SERVICE BULLETIN

NO. SB-1

Model: A2

Subject: C-90-16F Continental Engine Breather Fitting

FIGURE 3
(View looking inboard)
SCALE: NONE

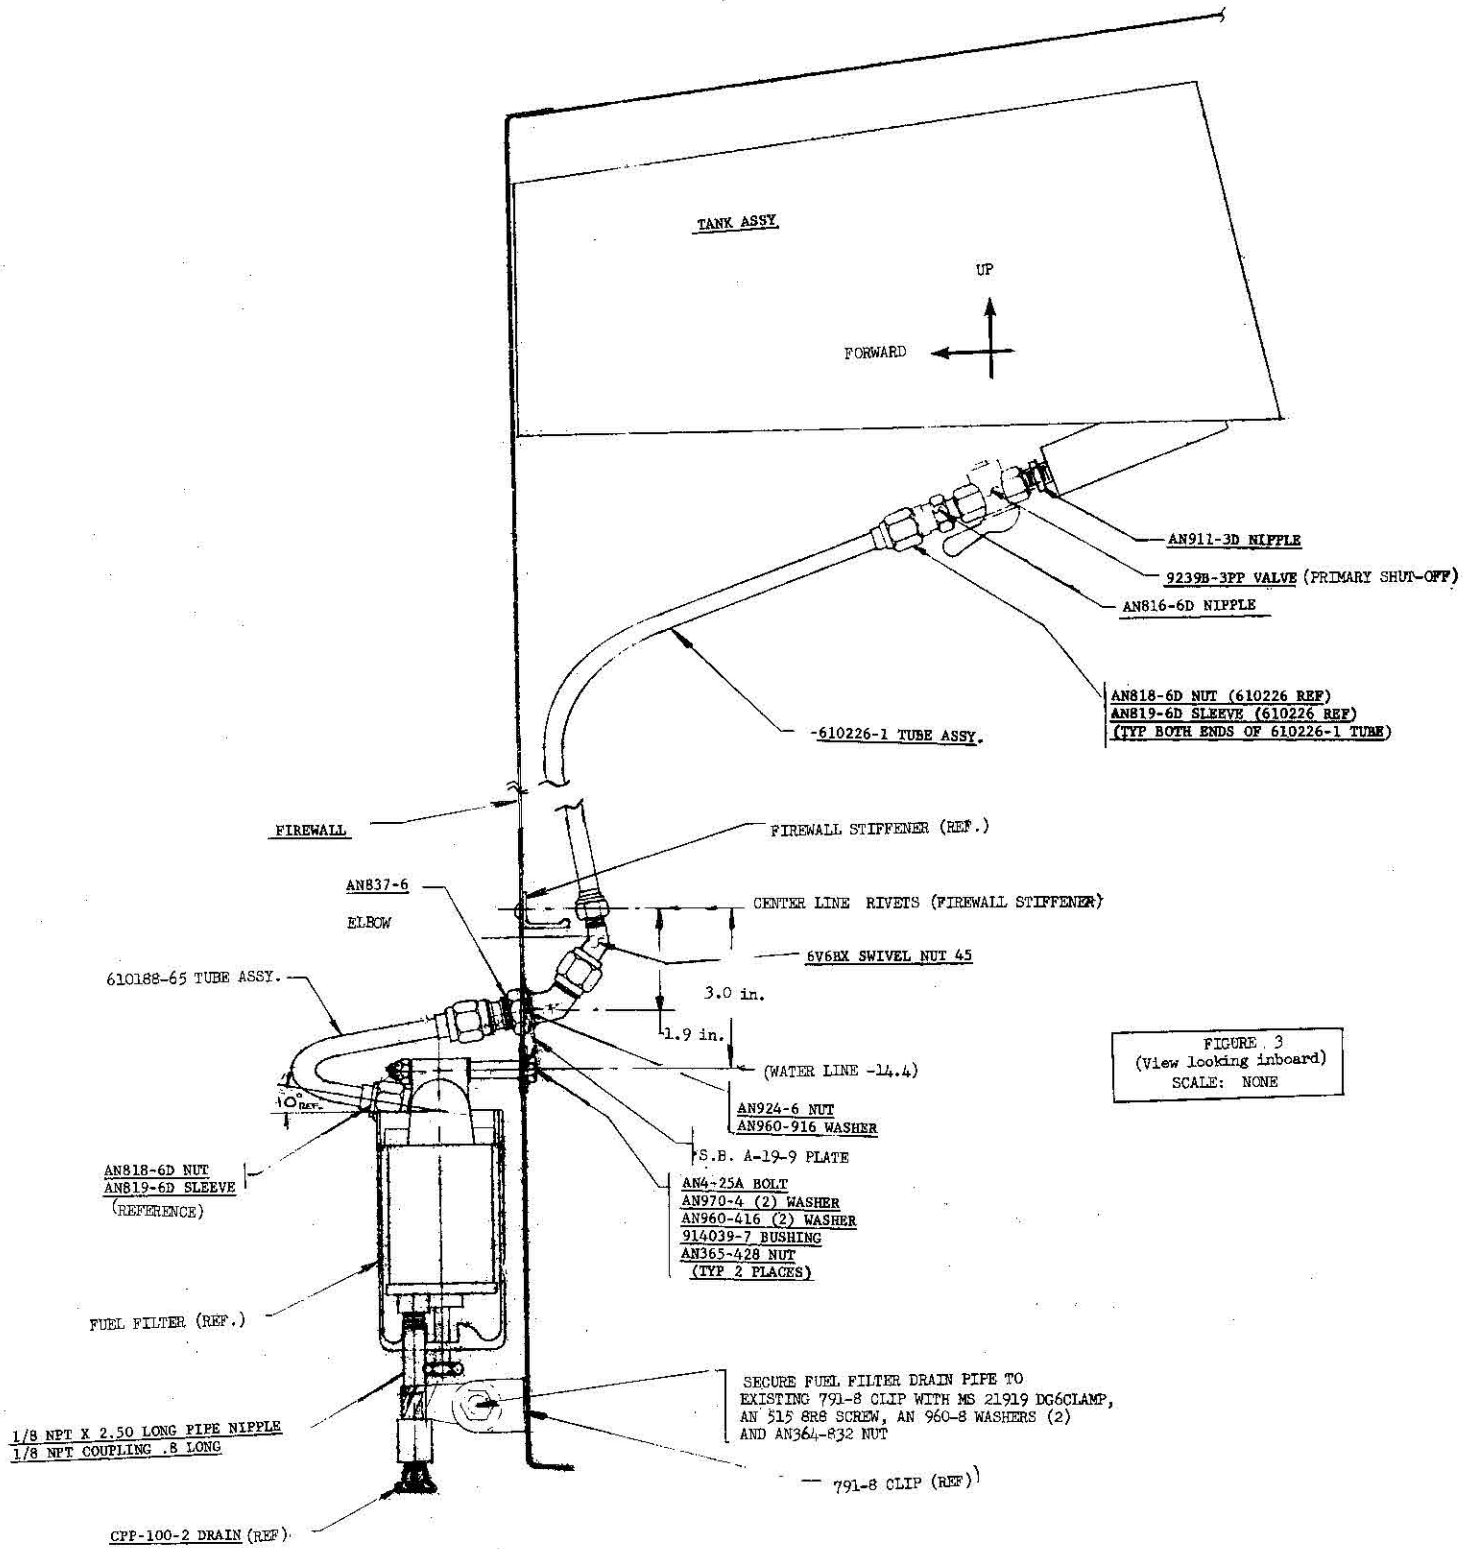
NOTE: This location is 3.0 inches below inside firewall stiffener rivet line (at Water Line -14.4) as shown on Figure 3; inboard and outboard location remains unchanged at butt line 3.0 left hand side (center line of fuel filter).

- d. Replace fuel drain pipe with 1/8 NPT pipe and coupling.
- e. Rotate the bottom of fuel filter 180° so as to allow the fuel filter drain line to match the existing cutout thru the cowling.
- f. Install MS21919 DG6 clamp (fuel filter support) on drain pipe and cup on firewall with attaching hardware as shown on Figure 3.
- g. Install fuel fittings on filter and firewall as shown on Figure 3.

- a. Install fuel line P/N 610226-1 between fuselage tank and firewall with hardware as noted on Figure 3.
- b. Install fuel line P/N 610188-65 between firewall and fuel filter.
- c. Leak-check all connections.

FIGURE 4
(View Looking At Firewall From Engine Compartment R.H. Side)

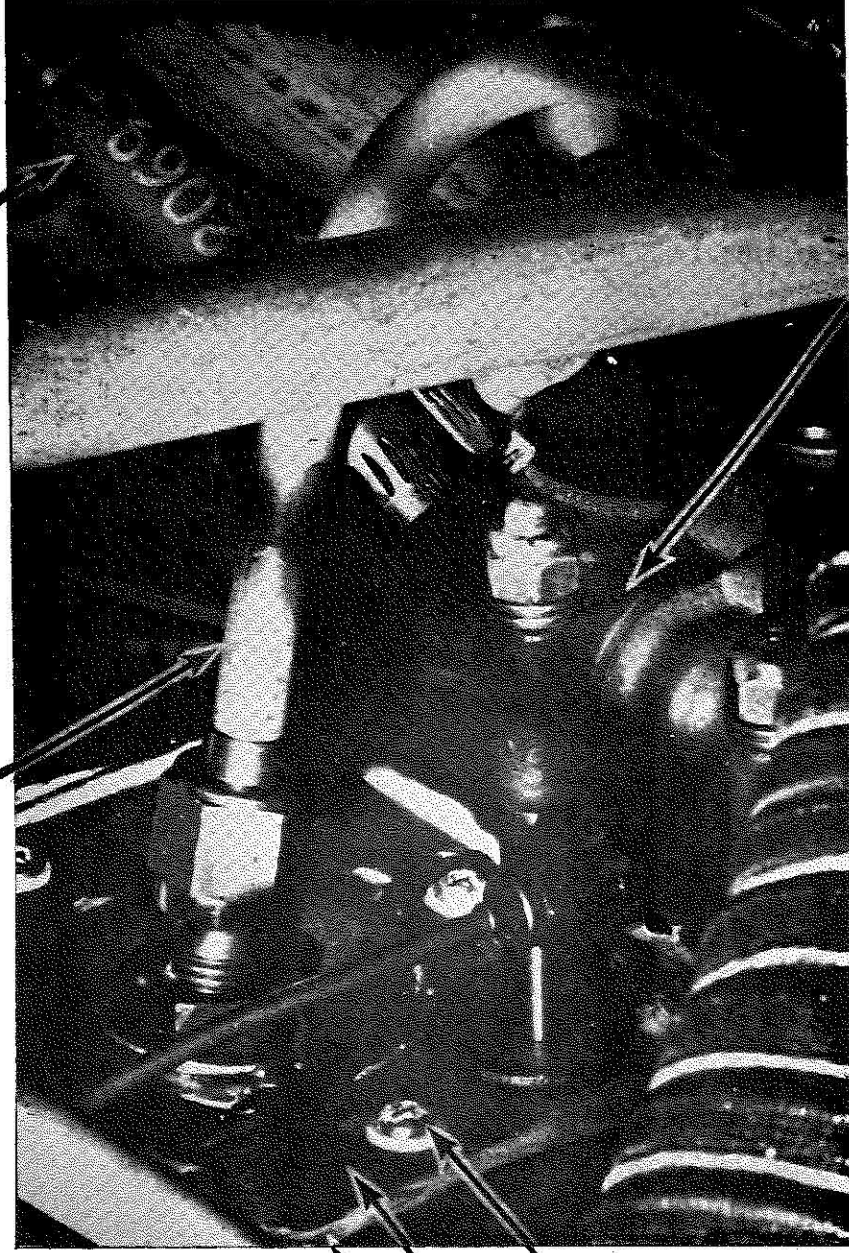
- a. Locate firewall plate S.B. A-19-9 as shown on Figures 3 and 4, on forward side of firewall, 1.9 inches below rivet line of inside firewall stiffener (new location at Water Line -13.3), and 1.1 inches inboard of inboard AN-4 bolt which attaches the fuel filter (at butt line 1.1 inches right hand side).
- b. Cut a 2.3 X 2.3 inch hole (radius bottom to match A-19-9 plate) centered at this location as shown on Figures 3 and 4.
- c. Center firewall plate on cutout and back-drill into firewall, thru existing holes on S.B. A-19-9 plate, eight .166/.170

- c. diameter holes. Remove all sharp edges and burrs.
- d. Apply PRC 1902 primer and PRC 1955 sealant to firewall skin outer faying surfaces around attaching holes, and install S.B. A-19-9 plate attached with eight (8) each AN515-8R8 screws, AN960-8 washers, and AN365-832 nuts (Refer to Figure 4).
- e. Plug existing fuel line hole in firewall with AN4-3A bolt, two AN970-4 washers, and AN365-428 nut.

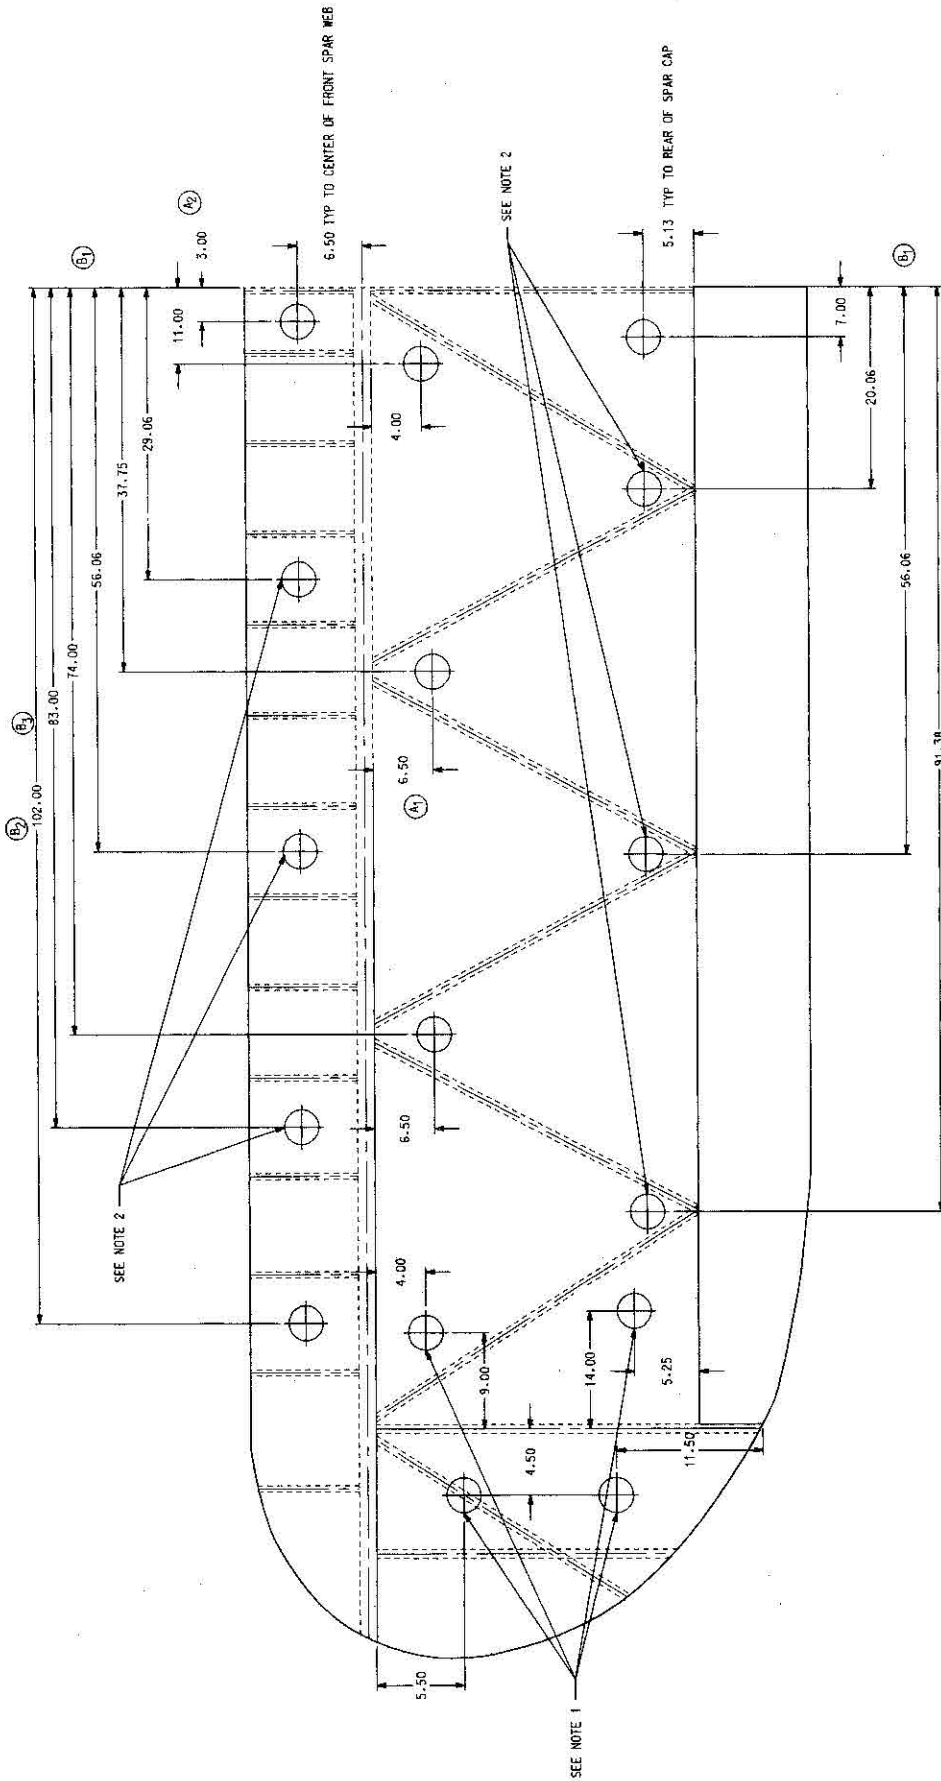
Locate inspection openings on the lower wing surface per the enclosed diagram, SB-29, Rev. B. Aircraft with factory covered metal skinned wings may already have existing inspection openings. SB-29, Rev. B, includes these openings.

Metal skinned wings - Cut 3.50 inch diameter inspection openings at the locations of No. 2 above and deburr.

After inspection is complete, install cover plates (P/N 483-10) in each opening. On metal skinned wings, secure each cover plate at the leading edge with one 4 X 3/8 TRA sheet metal screw.
